## REMARKS

Application Number: 10/601,721  
Amendment Dated: April 25, 2005  
Reply to Office Action of February 25, 2005

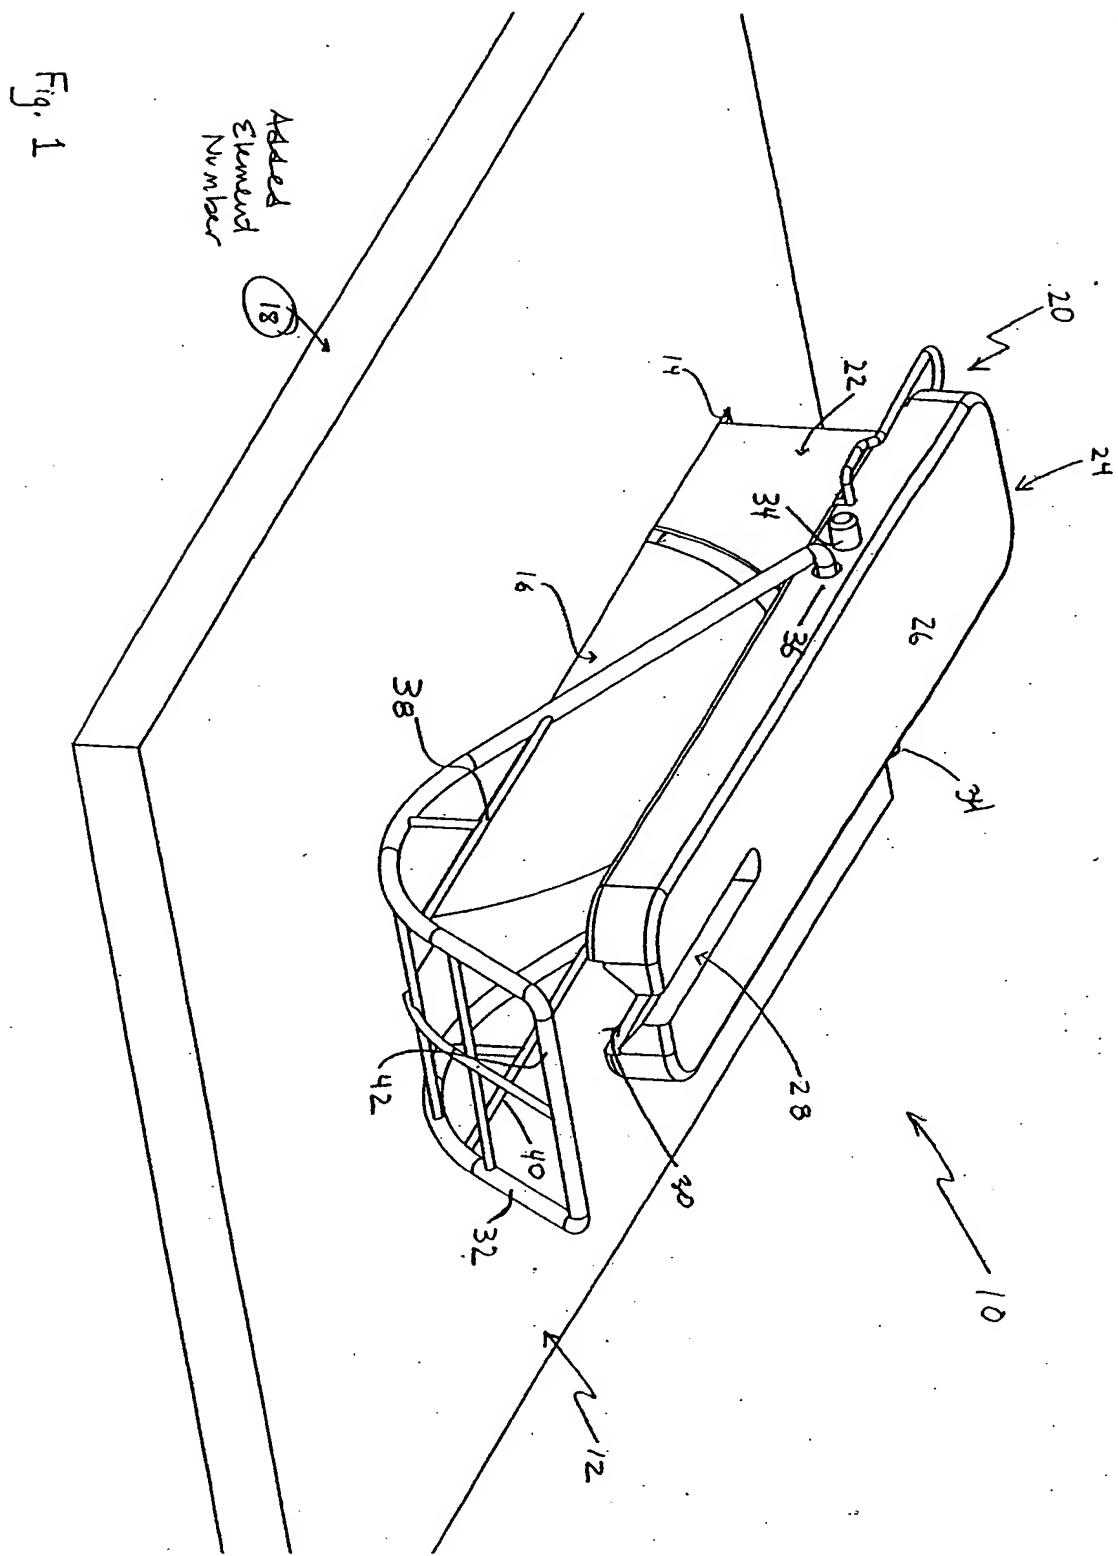
The Examiner objected to the drawings under 37 CFR 1.83(a), stating that the term "frame" as set forth in claims 1 and 17 must be specifically shown in the drawings. The Examiner stated that the replacement sheets filed with the Applicants' Amendment of November 15, 2004 were unacceptable because changes were made that were considered new matter because there was no support in the original disclosure for the specific structure added to the drawings. The Applicants respectfully disagree with the Examiner's contention.

no basis in the original disclosure for the changes made to FIGs. 1 and 4 by replacement sheets 1 and 2 that were filed with the Amendment. The Examiner's next logical step was to determine that because there was no basis for the changes made in the replacement sheets, there was no basis for the amendments that were made to the specification.

In order to expedite prosecution of the application, replacement sheets 1 and 2 that were included with the Applicants' Amendment of November 15, 2004 have been withdrawn. Applicants submit revised replacement sheets 1 and 2, which modify FIGs. 1 and 4, respectively. The only change on both replacement sheets from the as-filed figures is the addition of element 18, which identifies the frame, through which the saw blade extends and of which the table top is a part. The structure that element 18 refers to was shown in the as-filed versions of FIGs. 1 and 4. Because claims 1 and 17 each include limitations to a "frame having a table top" and as-filed FIGs. 1 and 4 each included the structure of the frame by showing the table top, and the replacement sheets, which only add the designation of element 18, do not add any new matter to the application. See MPEP § 608.01(l).

In order to expedite the prosecution of this application, the Applicants cancel the amendment made to paragraph [0022] in the Amendment filed on November 15, 2004. In place of the cancelled amendment, the Applicants have amended paragraph [0022] as set forth earlier in this Amendment. The current amended paragraph [0022] has the exact language that was used in as-filed claims 1 and 17 to describe the frame, in addition to the reference to element 18, which refers to the frame on the replacement sheets (corresponding to FIGs. 1 and 4, filed with this Amendment).
